# **Central Planning Authority**

**Agenda** for a meeting of the Central Planning Authority to be held on **June 8, 2022 at 10:00am in Conference Room 1038, 1st Floor, Government Administration Building, and Elgin Avenue.**

**CPA/15/22**

**Figure 1: 2018 aerial imagery showing the development (seawall line shown in orange) in relation to the historical (established) vegetation line (Source: LIS 2018).**

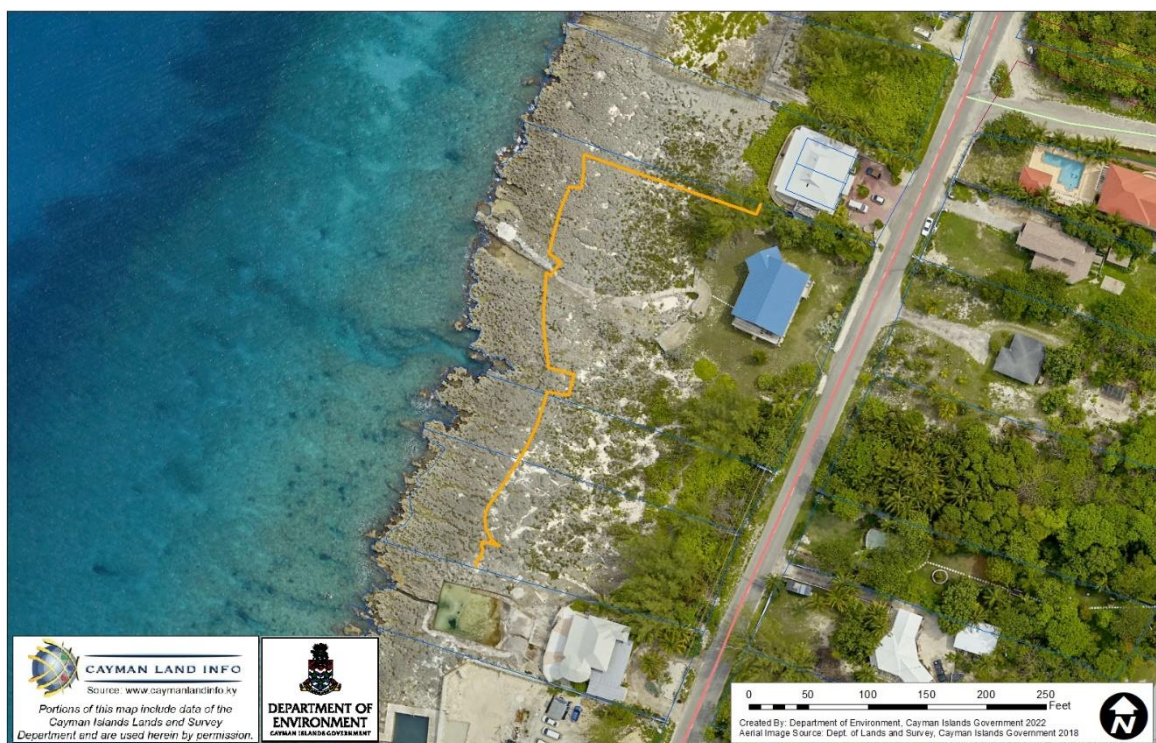
*The DoE also recommends that the ironshore coastline be left in its natural state. Aside from forming an important habitat, ironshore assists with the damping of wave energy and represents a unique and visually appealing vista. Developing directly on or driving heavy machinery over the ironshore removes much of these important physical and aesthetic characteristics and leads to the creation of fine material which risks causing turbidity in the marine environment due to surface water run-off. Although the plans*

do not show any proposed structures seaward of the 50ft setback on the ironshore, the artist's impressions that accompany plans do show what appears to be a concrete foot path along the northern section of the parcel toward the ocean. It is unlikely that the DoE would support a second concrete path along the ironshore as there is an existing concrete path near the ramp. Any further modification of the shoreline should be the subject of a separate consultation with the National Conservation Council.

**DISAPPROVED**      **B18-0502**      **( 8A219 )**

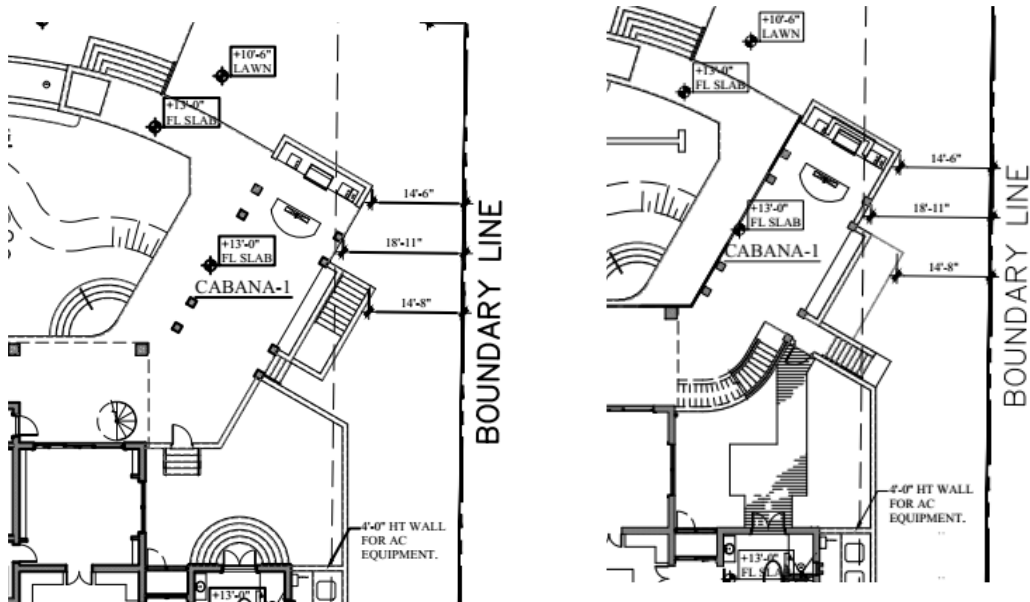
Rejection Reason: B18-0502 Main House 1) acquire planning modification and BCU approval for revisions to private garden area and spiral stairs 2) Final mechanical items outstanding 3) walkway/deck around house require guardrails installation per code for areas where grade fall greater than 29" 4) ACquire final inspection for below listed permits as noted B18-0503 CAR PORT - Final Building B18-0504 GUEST HOUSE - Final Building B18-0505 Caretaker house - Final Building (landing required at door) B18-0506 POOL - Final Building B18-0507 GARAGE W/GYM - Final Mechanical - Final Building B18-0508 Cabana - Final Building B18-0509 CABANA over pool - Final Building

***Below plans show approved condition (left) and proposed orientation of stair (right)***

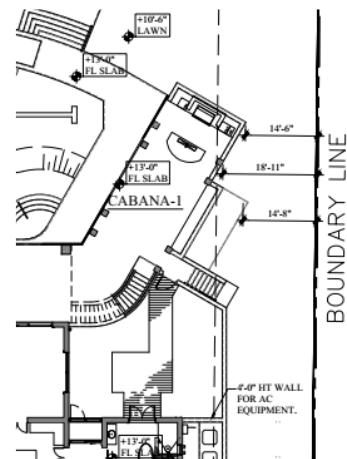
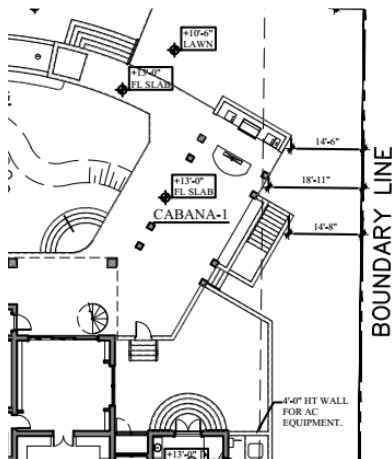
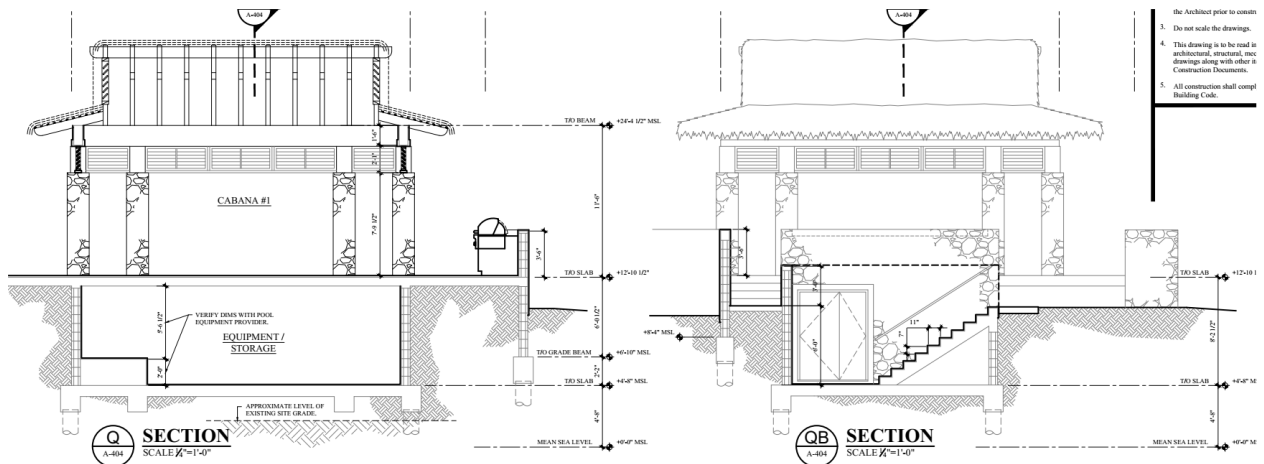
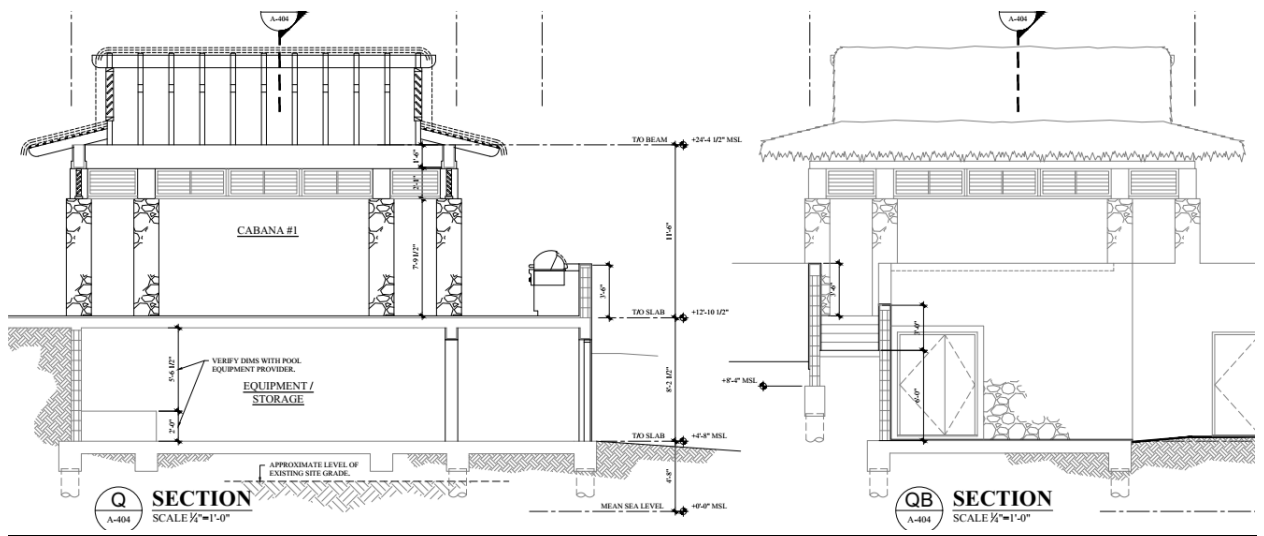
*It was decided to change the stairway access to the pool equipment room. Instead of having the approved and permitted basement stairs which were orientated to face the ocean, and thus might allow potential flooding of the pool equipment and storage space in time of storm, the grading on the east side has been reprofiled such that you can walk straight into the pool room rather than go down a “basement” like stairway.*

*Below plans show the approved pool equipment room configuration and the proposed “as built” configuration of the access and stairway configuration, for which the Applicant seeks the CPA’s approval. Kindly note the proposed stairway configuration maintains a similar setback to the previously approved setback from the eastern boundary.*

The applicant seeks the CPA’s formal re-approval of those elements projecting into the east side setback and to include the reconfiguration of the stairway leading down to the equipment room under the BBQ Cabana.

### ITEM#3 - BASEMENT BELOW CABANA

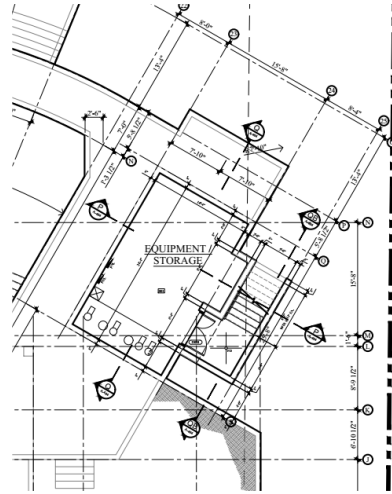
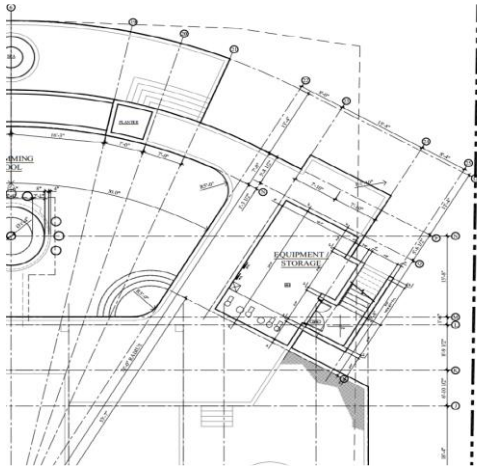
The minutes of CPA 11/22 item 2.16 appear to suggest the basement area under the pool cabana is an “after the fact” addition, which is not at all the case.

The basement plans for the house show the space below the Cabana as Equipment Storage, see **below (left)** snapshot from the P18-0450 approved 27th April 2018 drawings and also P18-0678 stamped Administratively approved 1st August 2018 drawings and **below (right)** snapshot from the building permitted drawings B18-0502 (dated 4 October 2018) :

***Figure 1: DOE's 2013 Habitat Map extract showing the application site outlined in red and the proposed land clearing footprint in purple (hashed lines).***

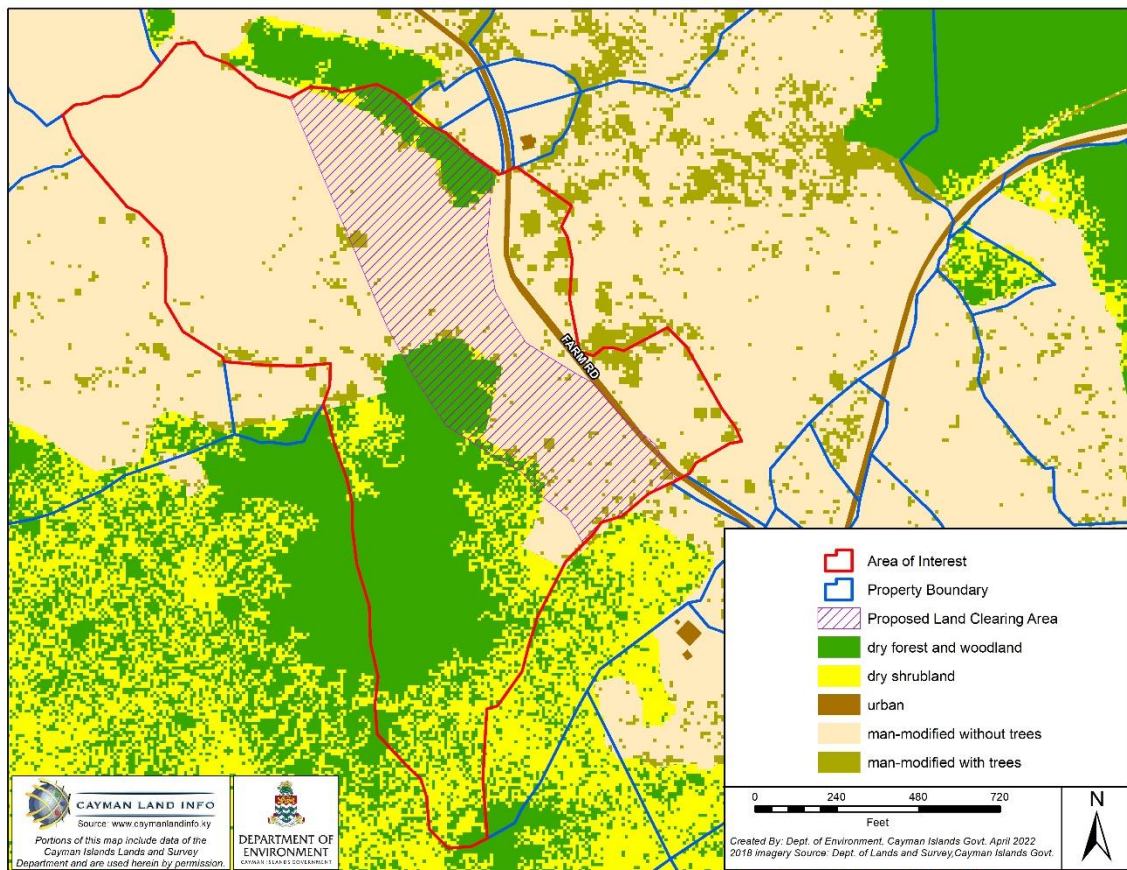
*The application site consists of a mixture of primary dry forest and shrubland habitat and man-modified areas as shown in Figures 1 and 2. Primary habitat is mature habitat in its natural state, otherwise uninfluenced by human activity where ecological processes are not significantly disturbed. These habitats are often very old, existing long before humans and may consist of many endemic and ecologically important species. These habitats are becoming rarer due to conversion from human activity and are under increasing pressure from climate change induced threats.*

**Figure 2: LIS 2018 aerial imagery showing the application site outlined in red and the proposed land clearing footprint in purple (hatched lines).**

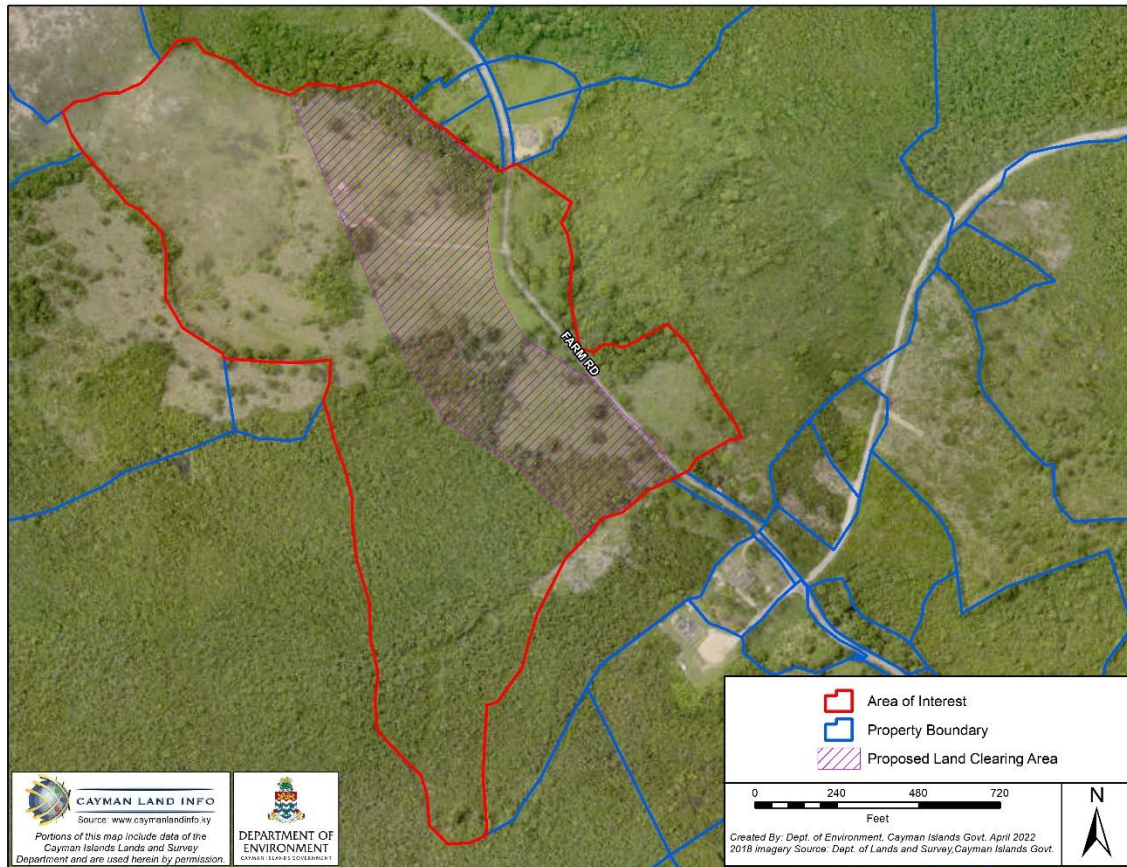
The impacted areas appear to have been used for farming in the past. However, the application site is likely in the habitat range of the Grand Cayman Blue Iguana (*Cyclura lewisi*). Blue Iguanas are listed as endangered on the IUCN Red List and they are a Part 1, Schedule 1 protected species under the National Conservation Act (2013) making them a species 'protected at all times'. Blue Iguanas are endemic to Grand Cayman meaning they are unique to Cayman and found nowhere else on earth. They are an iconic Caymanian flagship species and their presence serves as a valuable tourism asset.

**Figure 1: LIS 2018 aerial imagery showing the application site outlined in red.**

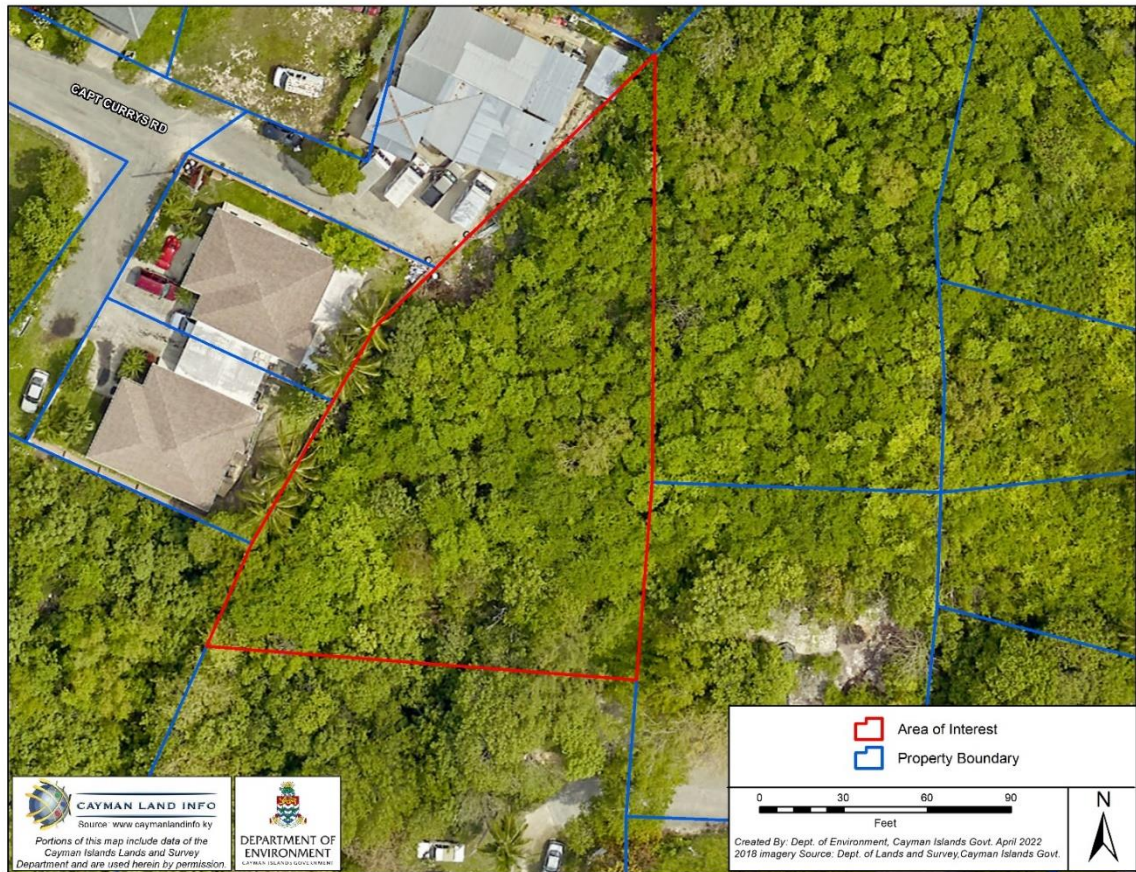
*The application site is man-modified with secondary regrowth as shown in Figure 1.*

*There has been no rationale provided for the land clearing included in the applicant's submissions, therefore, the DOE considers the proposal to be speculative clearing. The DOE does **not** support speculative clearing of parcels prior to planning permission for development being granted. We recommend that applications for land clearing are presented along with the development proposal so that appropriate mitigation measures can be recommended, as there may be varying recommendations depending on the form and nature of the development being proposed. Once planning permission has been received, the DOE encourages applicants not to undertake land clearing until development is imminent to allow ecosystem services to continue to function until they are ready to begin construction. We also encourage applicants to retain as much native vegetation as possible to incorporate into the landscaping scheme. Native vegetation is best suited for the habitat conditions of the Cayman Islands, requiring less maintenance and less supplemental irrigation. Once it is established, landscaping with native vegetation is a very sustainable and cost-effective choice.*

Figure 1: Aerial imagery showing the subject parcel (Source: Lands and Survey 2018)

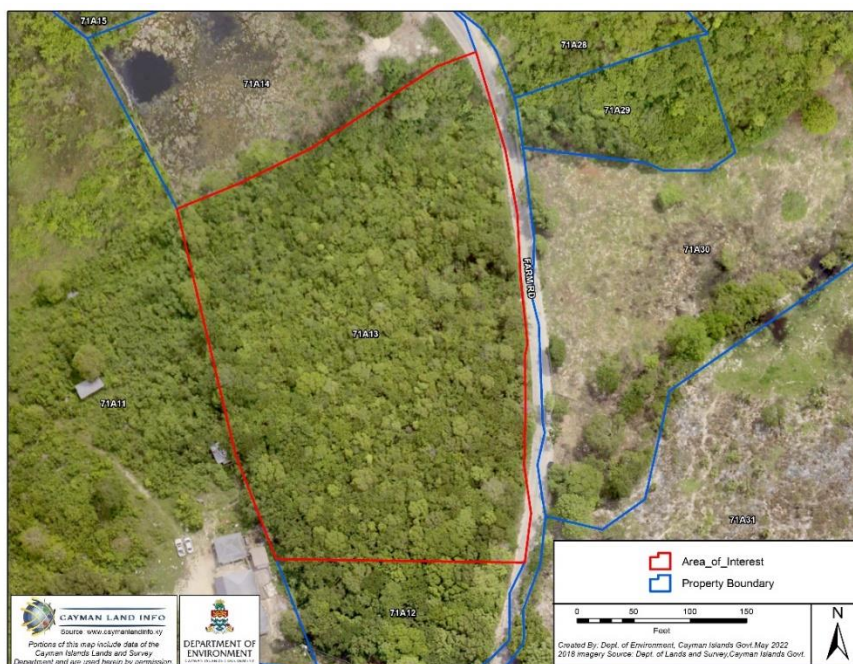
*The Department notes that the subject parcel is man-modified with regrowth as shown in Figure 1 below. A review of the Lands and Survey Department's historical aerial imagery confirmed that the site was previously cleared; possibly to be used as a pasture lands in the 50s. However, there has been significant regrowth over the decades and the DoE would not support the clearing of the parcel at this time as we do not support speculative or wholesale clearing of subdivision sites.*

*In principle, land clearing should be reserved until the development of individual lots is imminent (through the granting of planning permission for development on those particular lots). This allows the opportunity for the individual lot owners to retain vegetation and allows the site to continue to provide ecosystem services such as providing habitat for wildlife, assisting with stormwater management and storing carbon.*

Figure 1. The environmental context of the site showing the seaward extent of the proposed development (yellow).

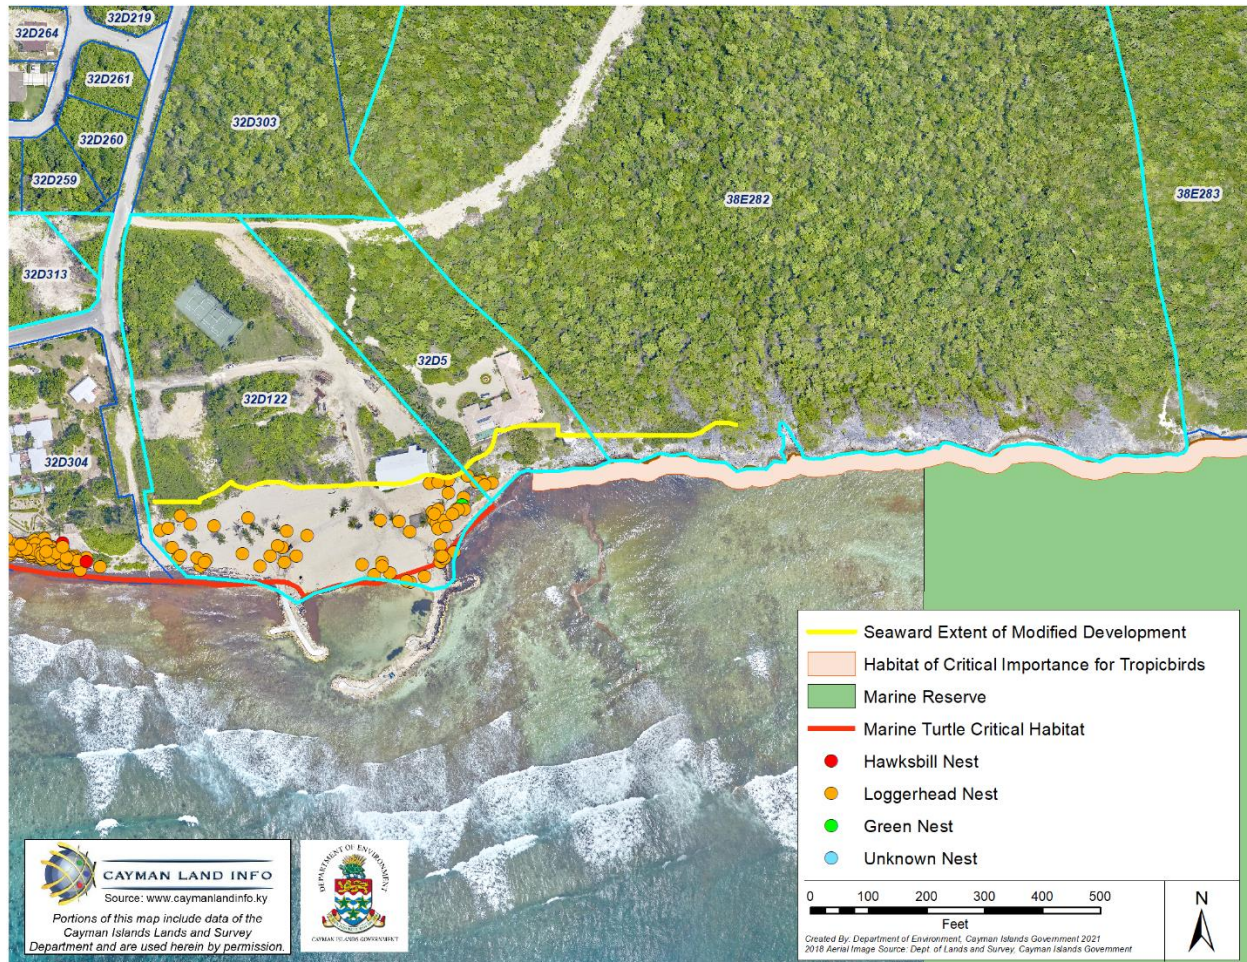
The environmental context of the site is shown in Figure 1.
